Project Name: Whitemarsh Collision Parking  
Expansion (Waiver Request)

Reference: Request for Waiver of Land Development  
Whitemarsh Collision  
4100 Butler Pike  
Whitemarsh Township, Montgomery County, Pennsylvania  
SLD #09-24

**RE: SLD #09-24: Whitemarsh Collision, Inc.; 4100 Butler Pike  
Land Development Waiver Request for New Parking Lot  
Zoning Ordinance Compliance Review Letter**

GP#2024-26 Paul & Mary Lou Bartle-- Whitemarsh Collision (4100 Butler Pike)

**SHEET NO.**  
**SP-1**  
**DATE:** 3/11/25

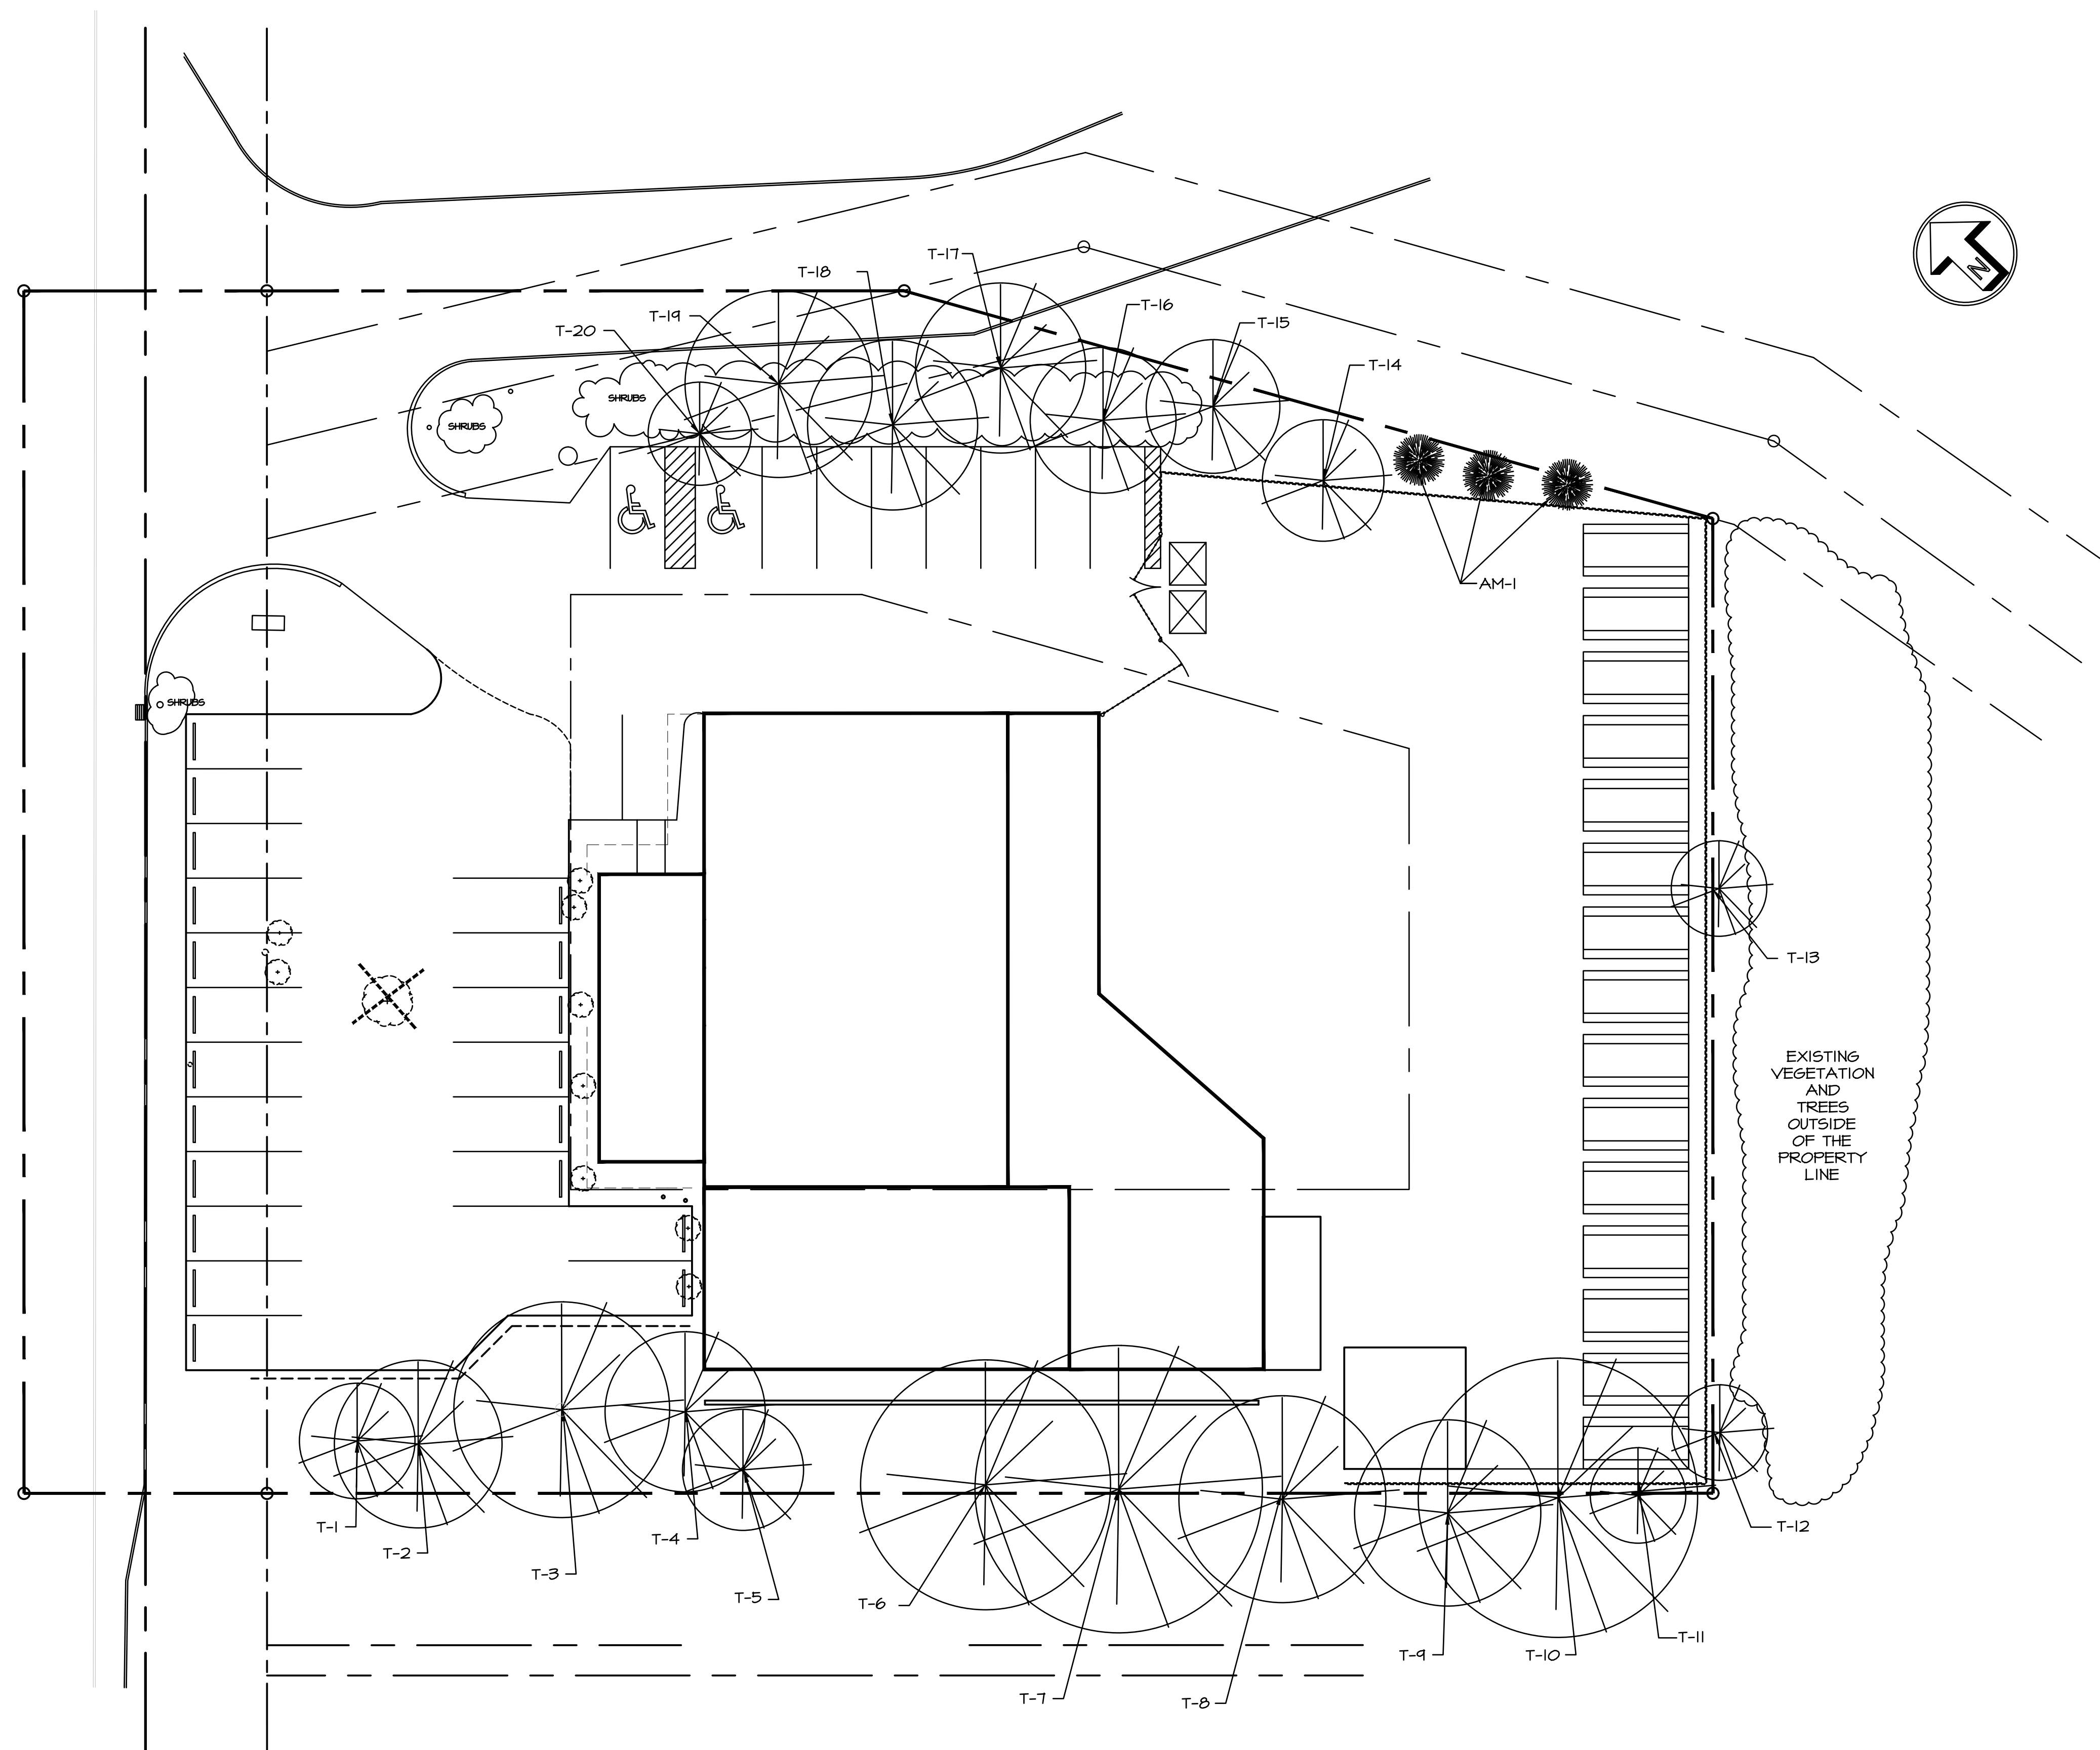
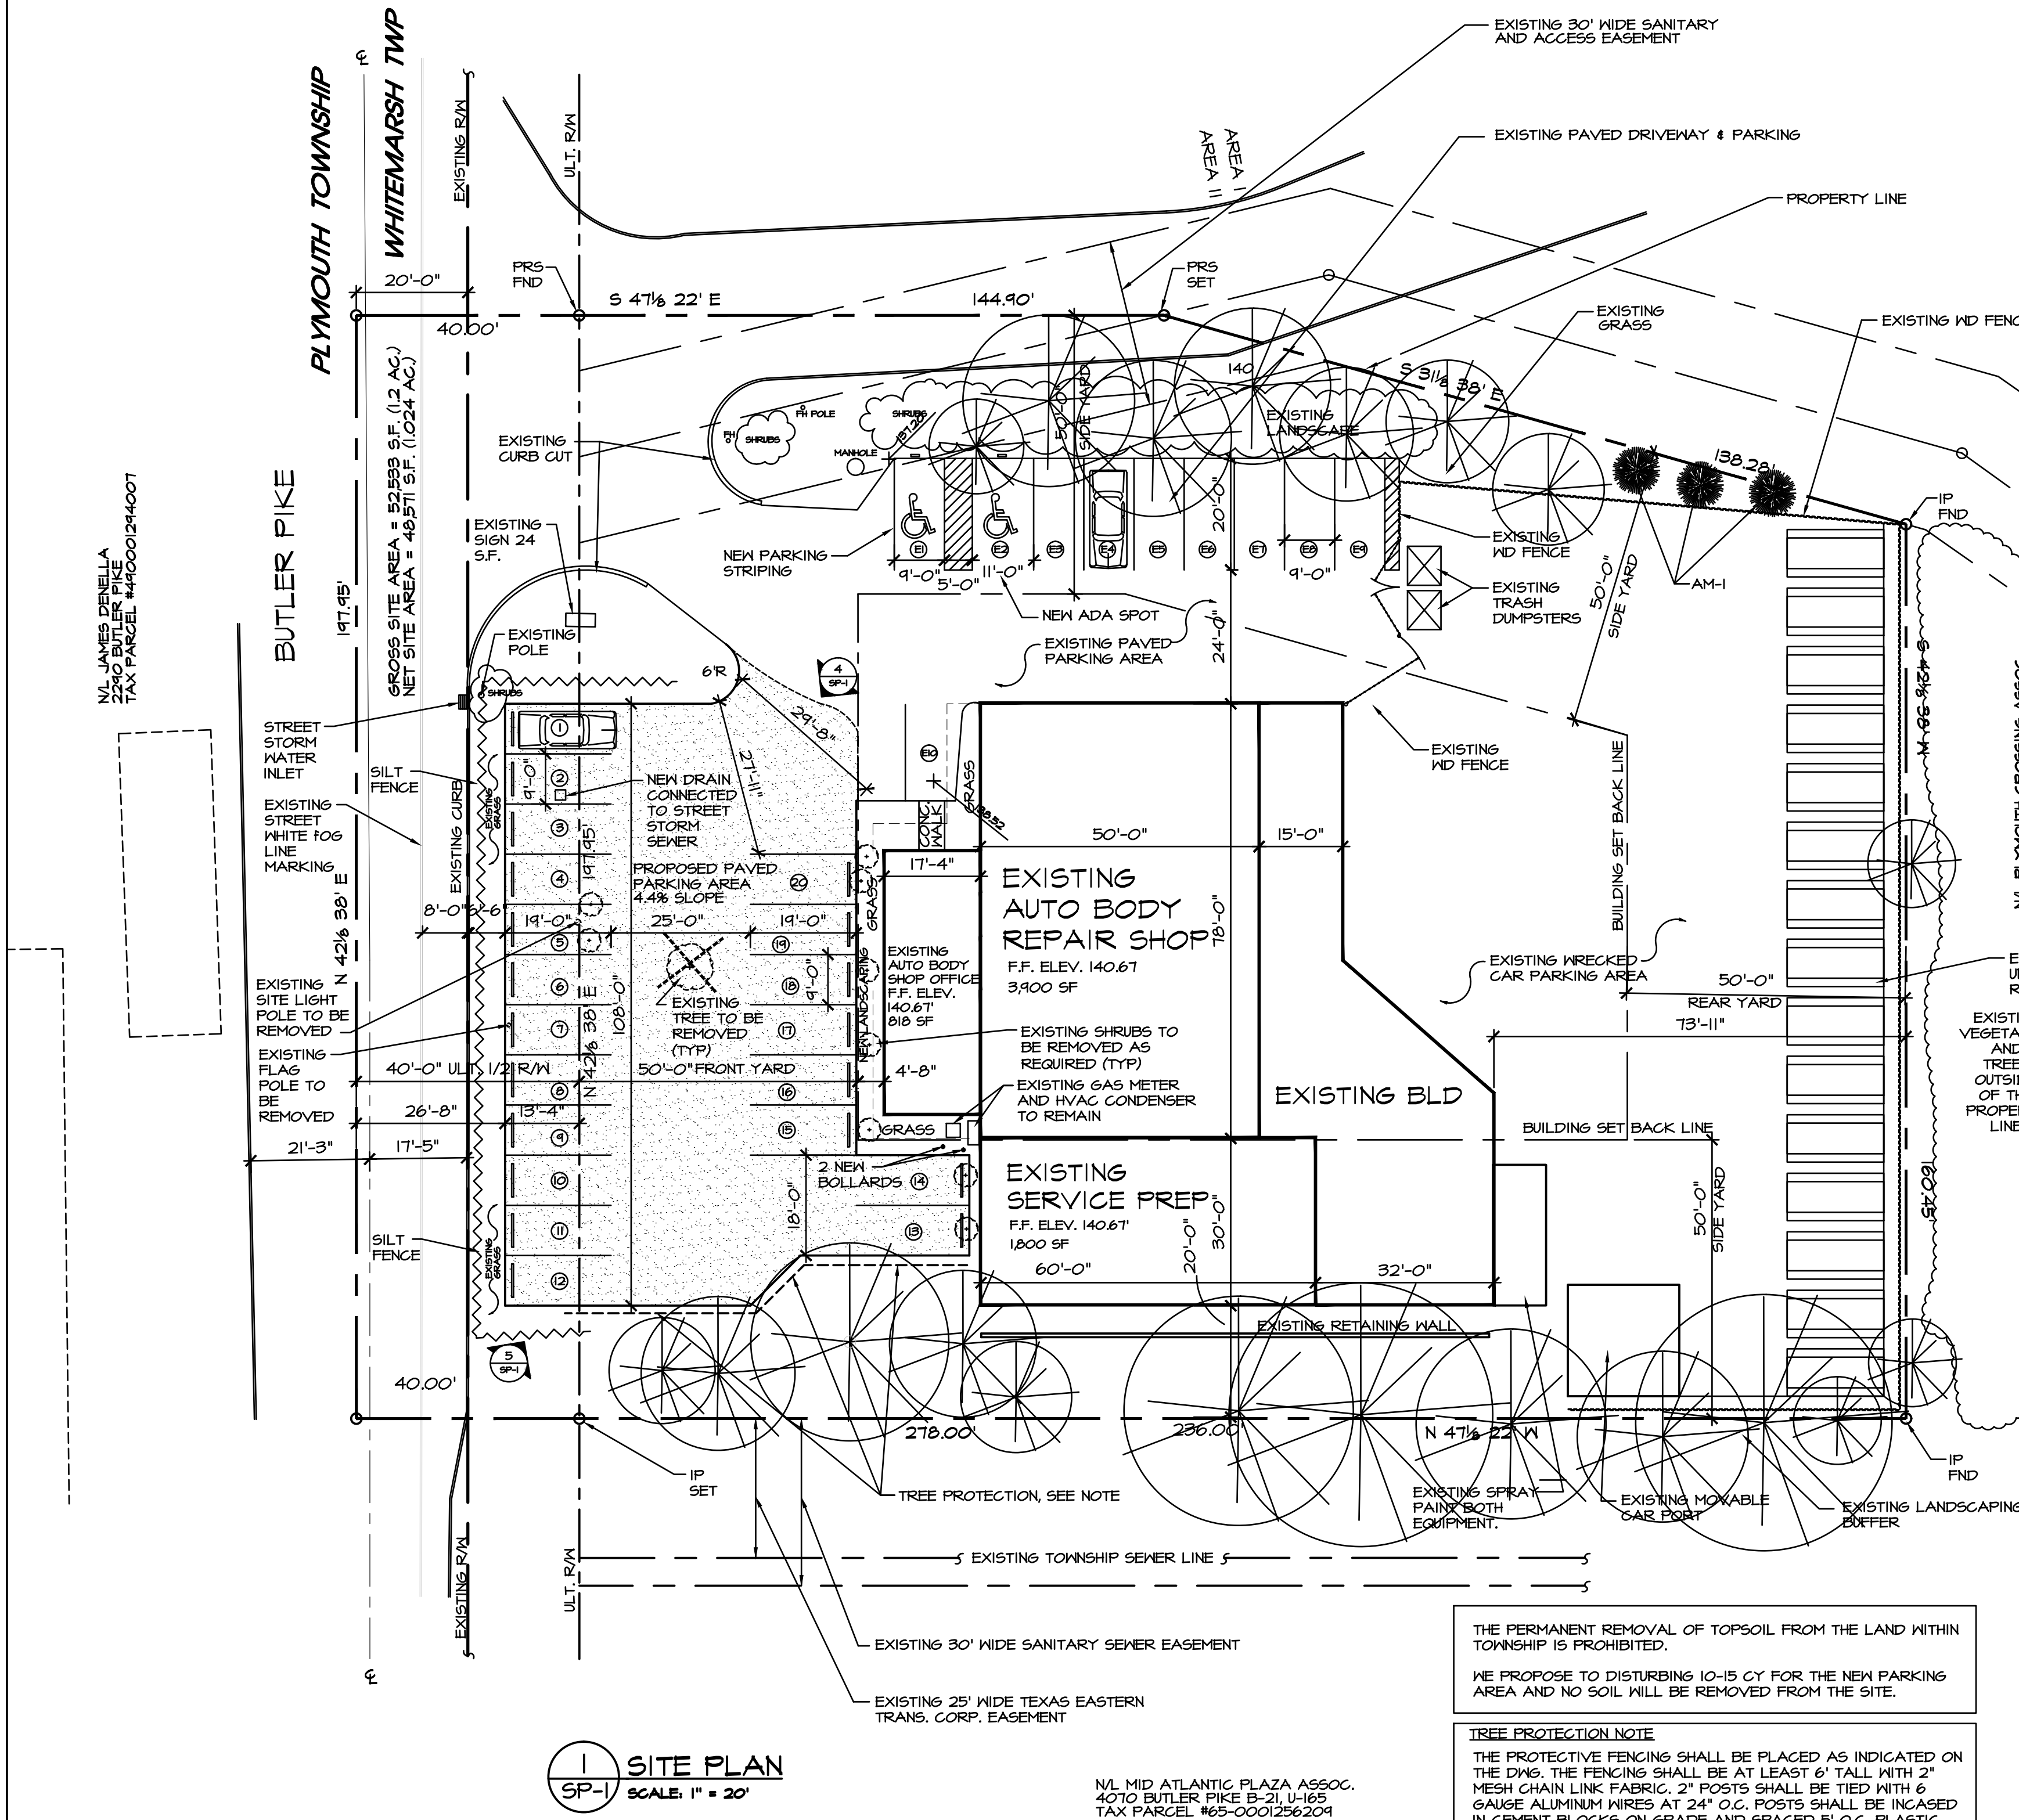
**Tree protection is shown for the area of concern. The remaining trees will not be impacted due to curbing or existing infrastructure. This is compliant for this application.**

**A total of 9" (3 trees) is being proposed. The applicant, on the plan, is showing Armstrong maple trees. These trees are adequate for this application as they will not require reduction, drop tree litter on customer cars and will provide marginal shade.**
